DESCRIPTION: HYD DISC 1X96" WIDE 3740GVWR SPRINGHYD DISC HYDRASTAR 1X96" WIDE 3740GVWR STR SPRING 4" TNG	PART #: 400-036321
EFFECTIVE DATE: 10-05-20	ECN: 1166

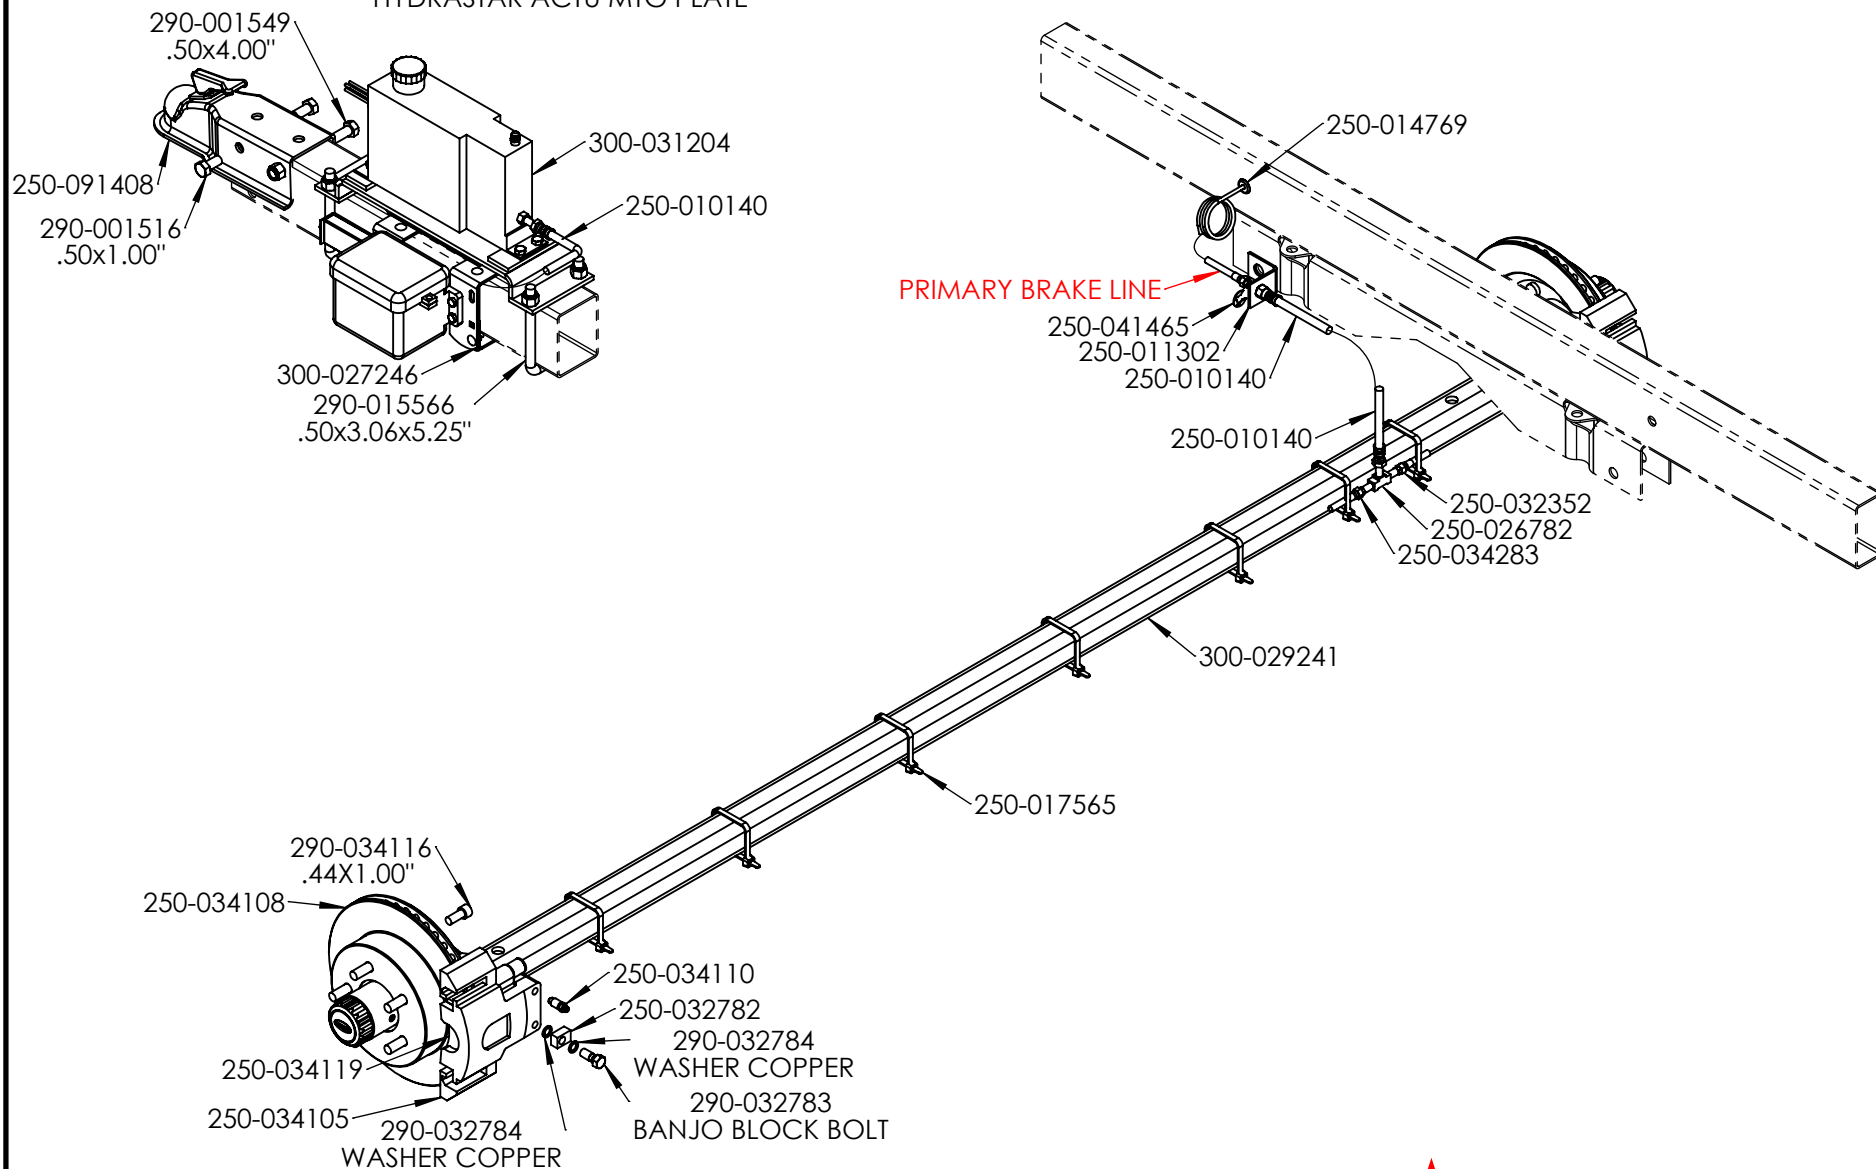
NOTE:
~RUN HYD HOSE BEHIND THE BATTERY BOX AND UNDER
HYDRASTAR ACTU MTG PLATE

NOTE:
~APPLY 250-033537 COPPER GASKETS TO ALL FLARED FITTINGS
~SEE UFP DISC BRAKE INFO PAGE

★ INDICATES CHANGE ON EFFECTIVE DATE
